This bulletin is additional to the December, 1980 issue, which therefore continues to be relevant.

We start in the same manner as before, reviewing modifications.

Points De-Isolating Clips M.1185

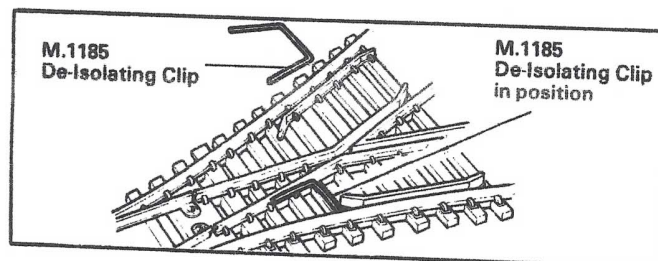
The fitting of these clips to Hornby self-isolating points, as shown, counteracts the self-isolating feature. This is a simple way of ensuring that all parts of a layout are fully electrified, as required for Zero 1 operation. Supplies are available from the Rovex Service Centre, at a retail price of 32 pence per dozen. Two clips are required for each point.
